**Format**  
HOMES

**Submission**

**Phase Three of the Planning and Design Code  
(Urban Areas)**

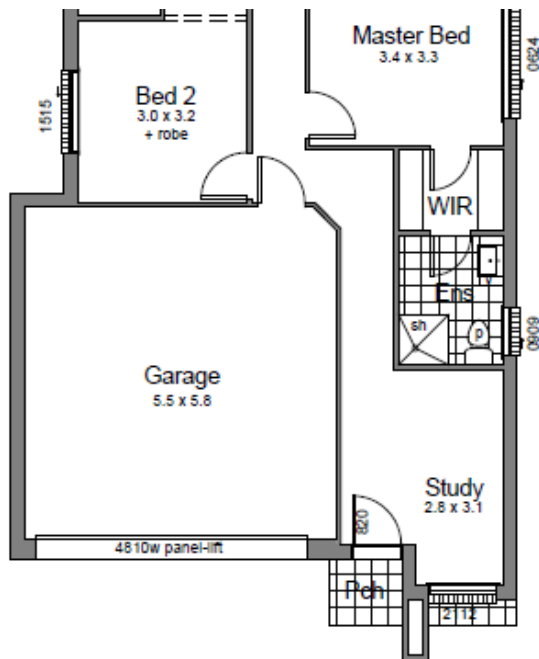
One of Format Homes' most popular plans is the 'Ashton 3' (the front of this design being shown below), which is on display at Seaford Heights and provides a 10 Metre wide home with a double garage and fits on a 300m<sup>2</sup> allotment. This home is compliant with the current 'ResCode' requirements, and obviously suits a great number of those building new homes.

DTS / DPF 18.1 has obviously been written to remove this popular option from the market. Our view is that this is short-sighted given the following:

It is our evident to us that the market has a strong preference for secure, undercover car parking provisions and this DTS/DPF totally removes this option. This has been allowed under the ResCode provisions for the last eleven years and, while it may not aesthetically appeal to everyone has been increasingly popular.

Again referring to our 'Ashton 3' design earlier, these two requirements would appear to be setup specifically to eliminate these quite popular types of homes from the market, without actually addressing the stated objectives.
